CARMICHAEL-KEMP, ARCHITECTS

MEETING NOTES

PROJECT: WILLARD ELEMENTARY

MODERNIZATION PROJECT

3 SOUTH EXTERIOR ELEVATION

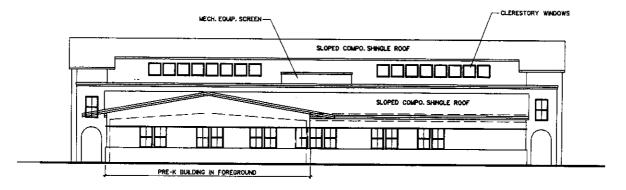
- 1.01 Tammy reviewed the attached plans showing the modified site design and floor plan layout, along with review of preliminary exterior elevations.
- 1.02 Preliminary exterior elevations have been developed. In order to try and tie the design of the modulars to the existing building, both design elements and in scale, a tall clerestory between the two kindergarten units and taller façade walls at each end of the complex are proposed. The end façade walls contain arches that tie to the arched element at the south end of the main building.
